Wayzata Planning Commission

Project Name: Zitzloff Redevelopment
Applicant: Lowell Zitzloff
Addresses of Request: 305 and 309 Lake St E
Prepared by: Jeff Thomson, Director of Planning and Building
“60 Day” Deadline: October 26, 2018 (120 day extension)

The Design Review Critique is based on the following plans submitted by the applicant:

ALTERNATE SOUTH ELEVATION
WITHOUT ROOFTOP PATIO

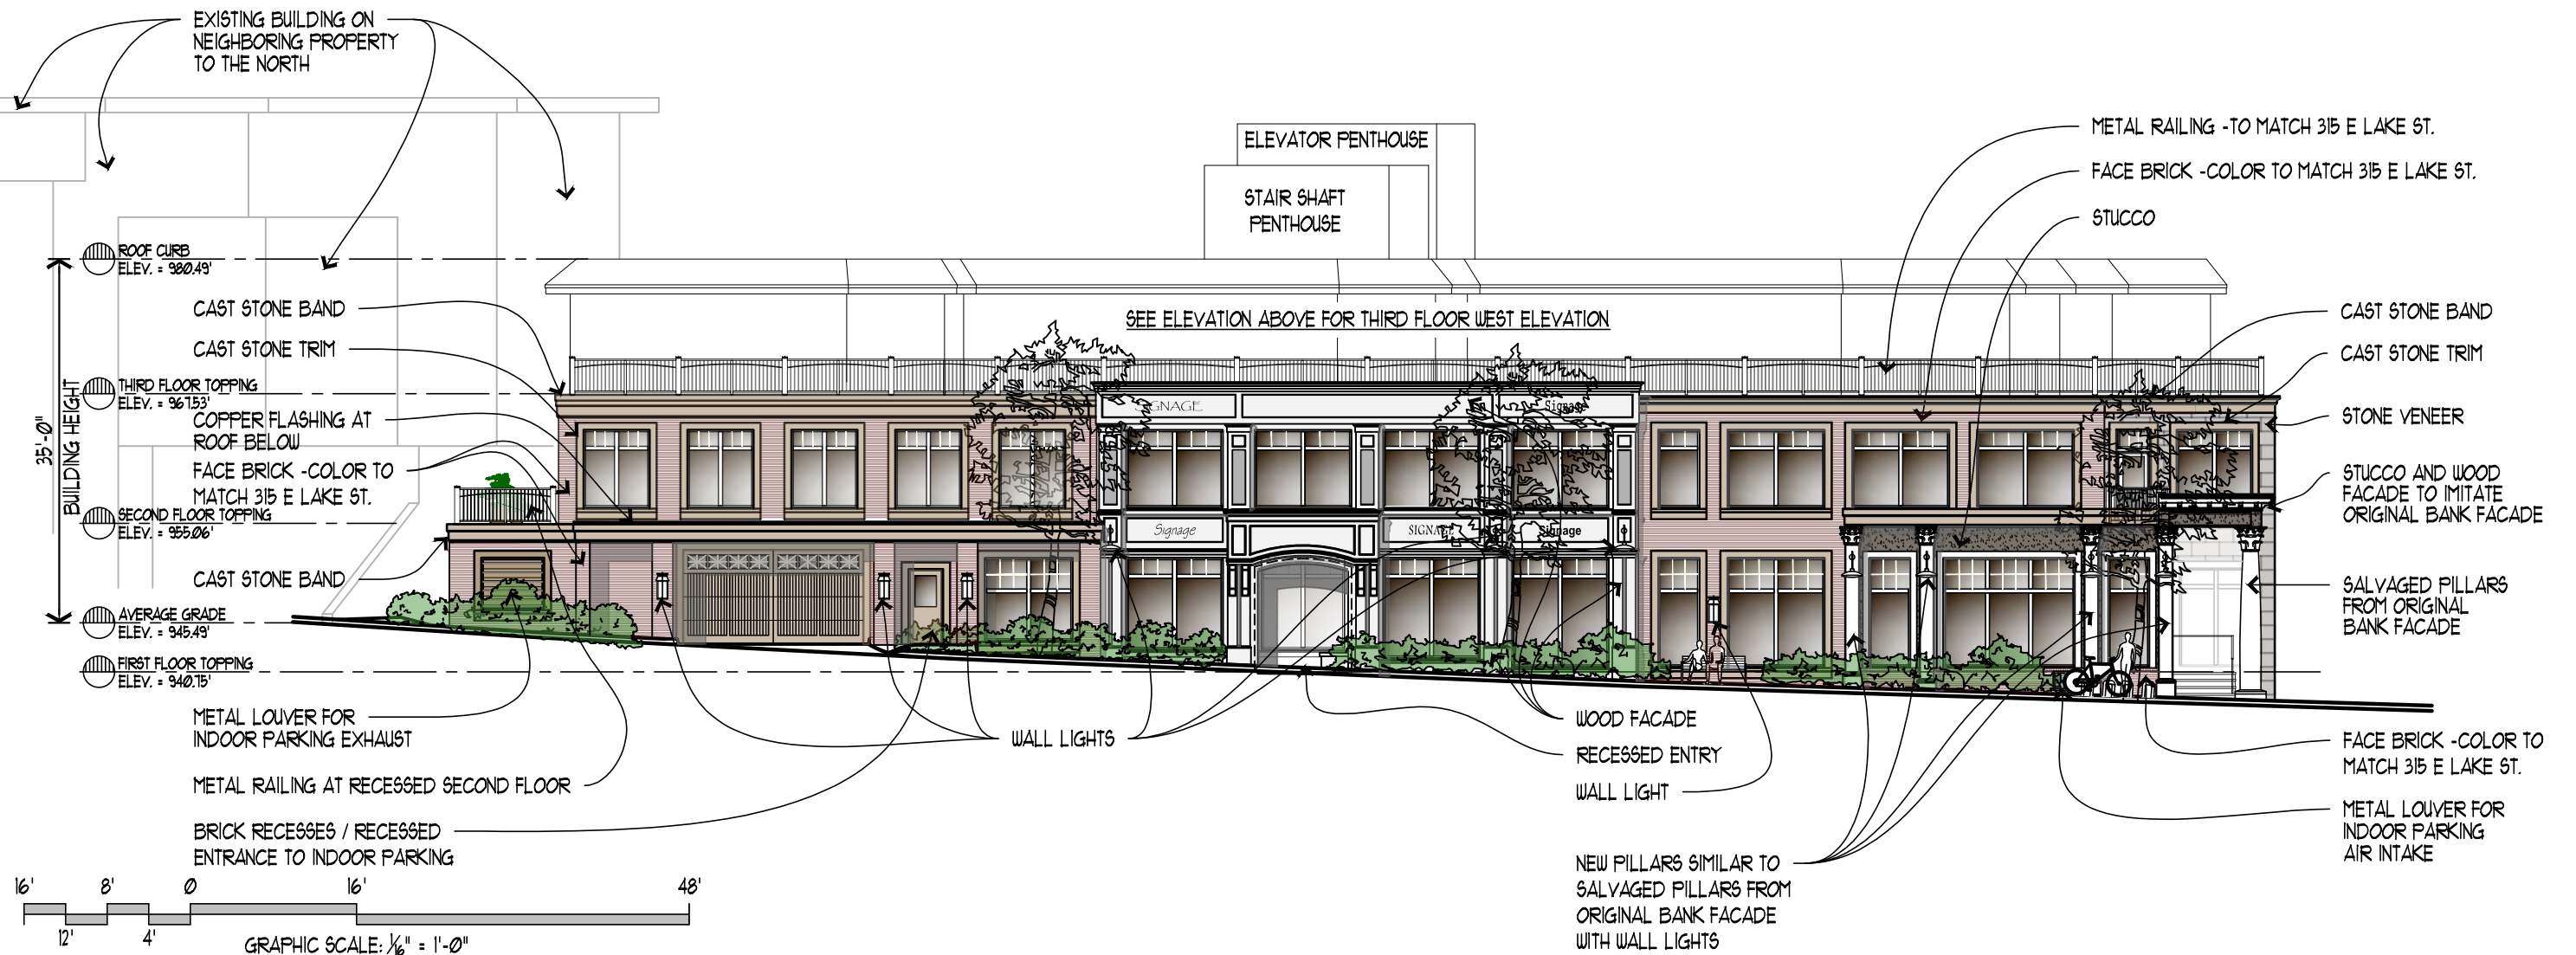
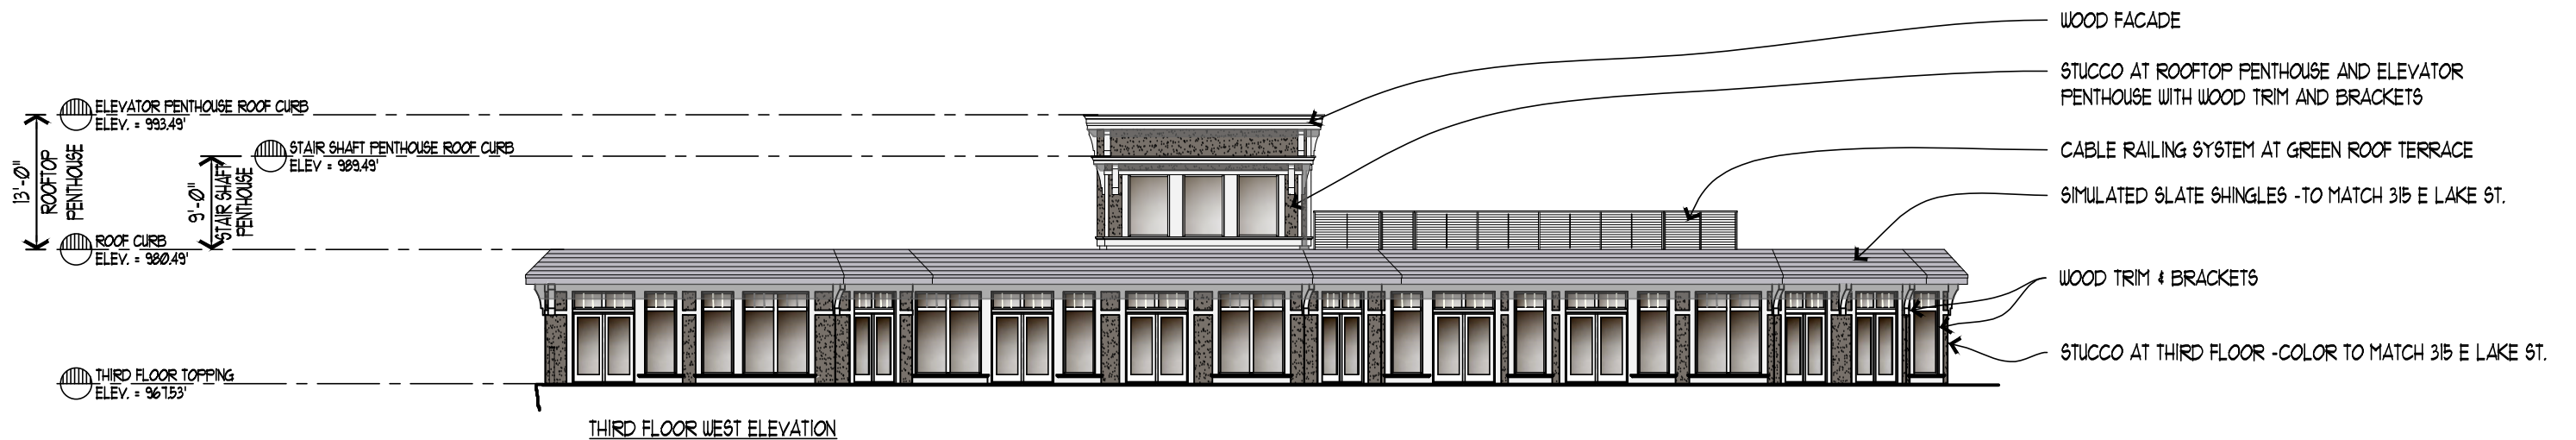
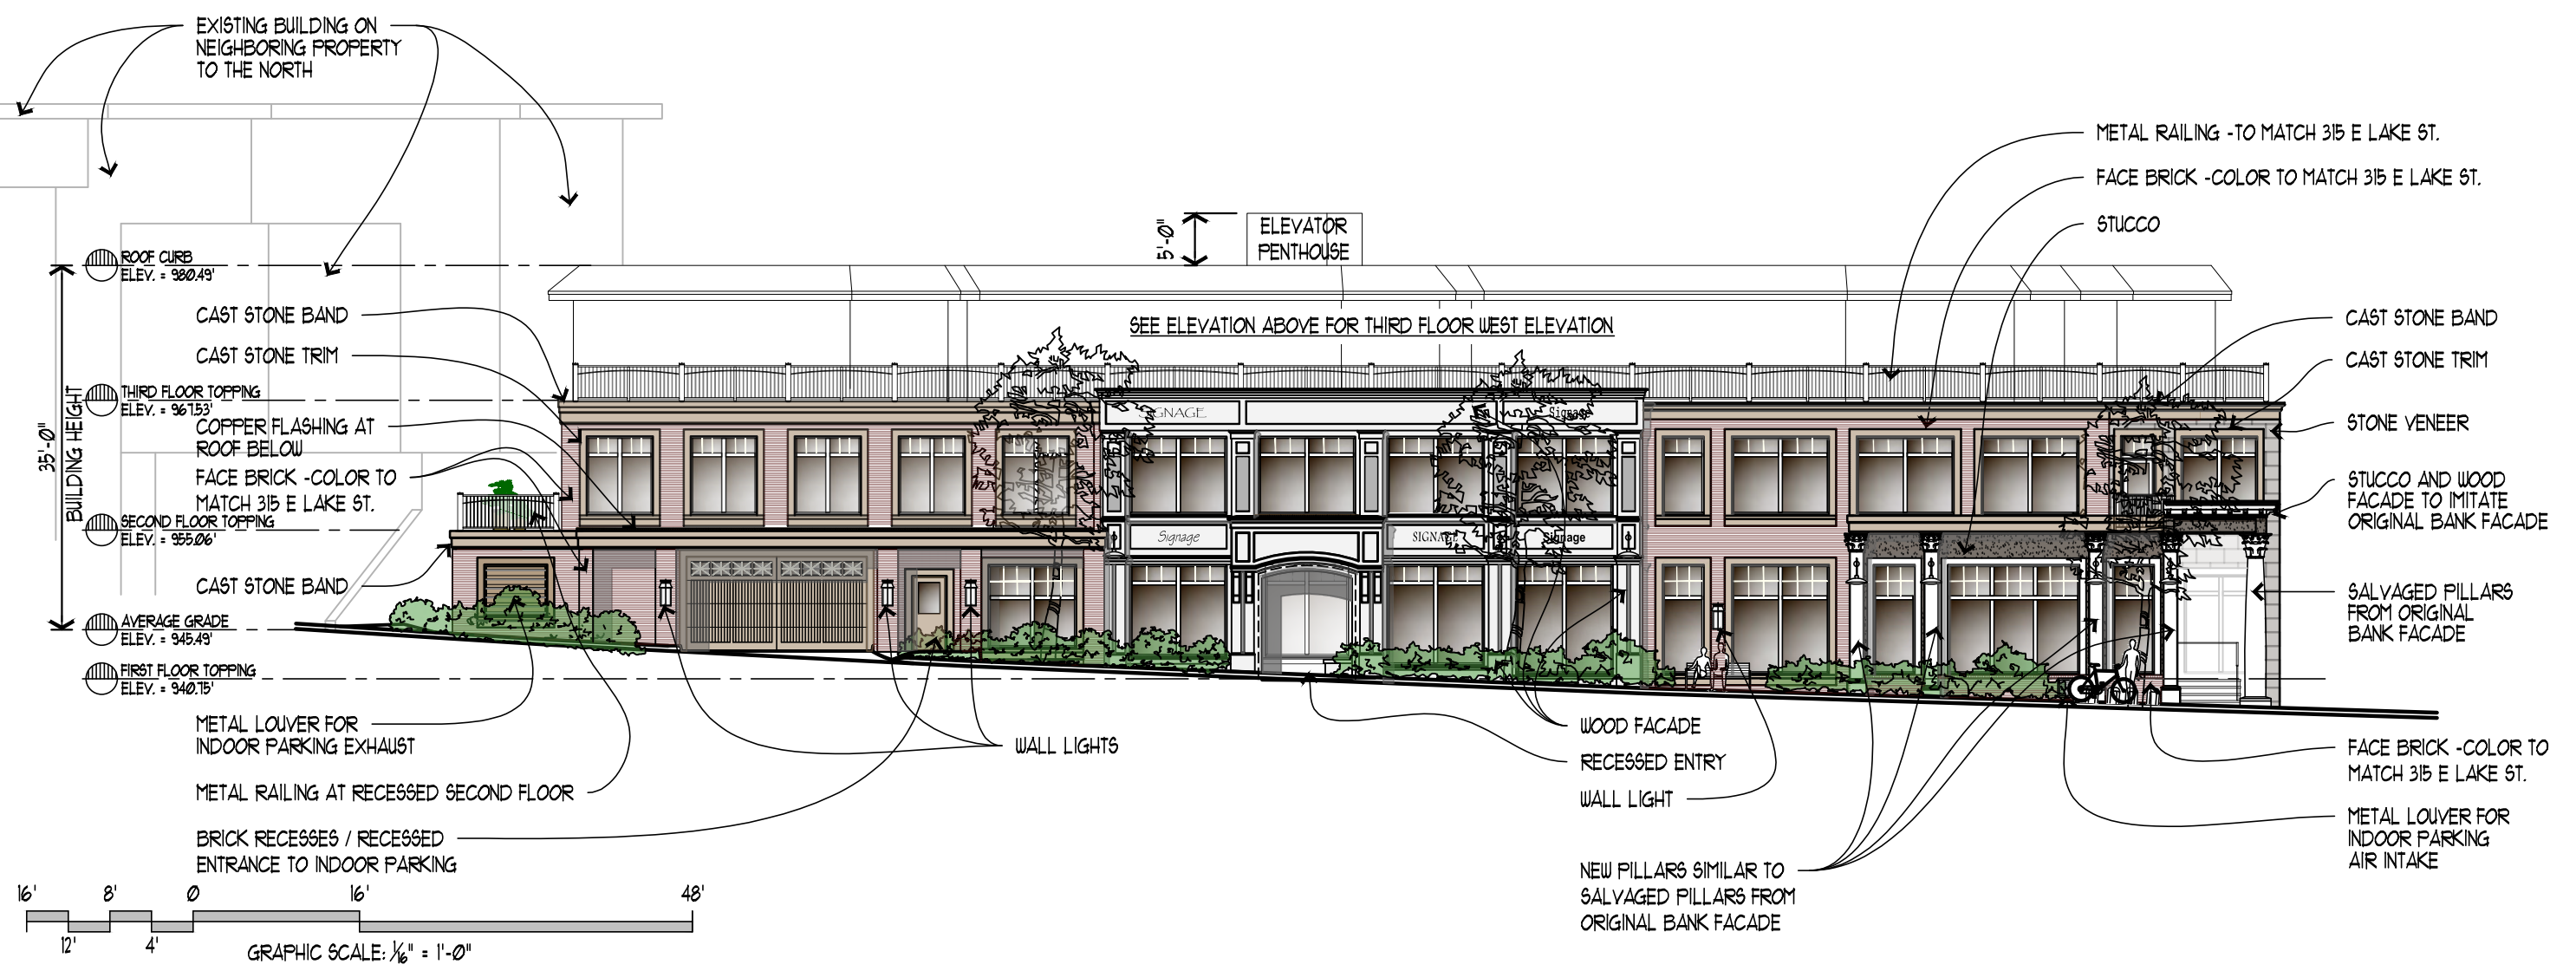
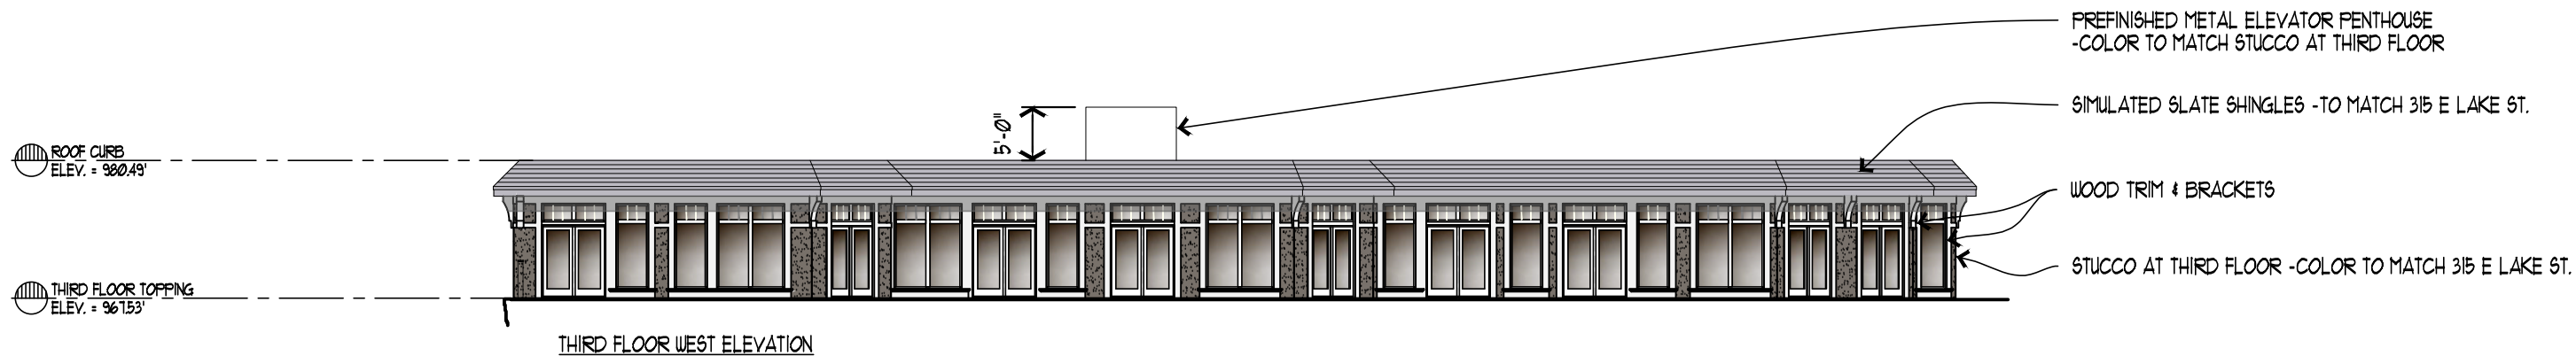
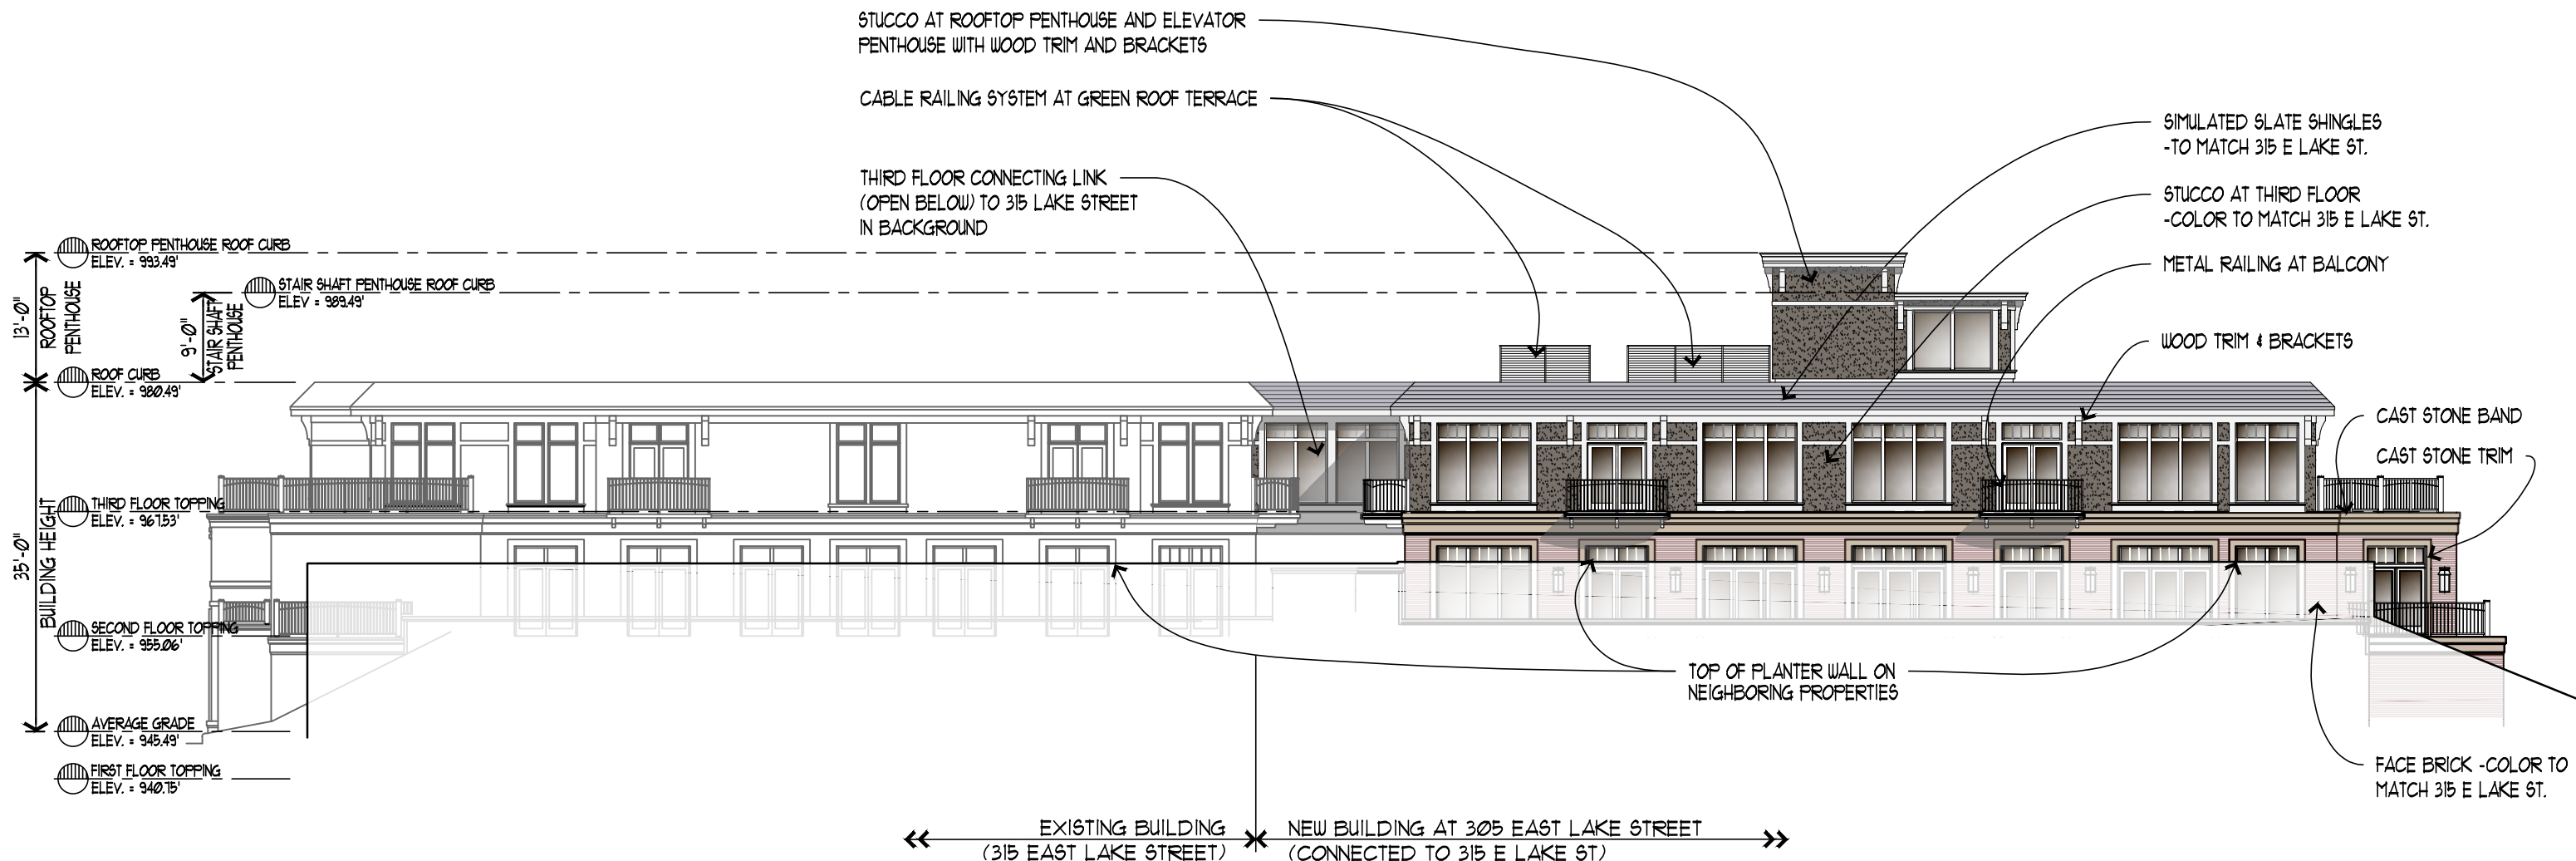
Therefore, the proposed building height of 44 feet to the fourth story and 48 feet to the elevator overrun requires a variance and a conditional use permit/shoreland impact plan. The alternative plan, which eliminates the fourth story and rooftop patio, would comply with both the C-4 and shoreland overlay district requirements.
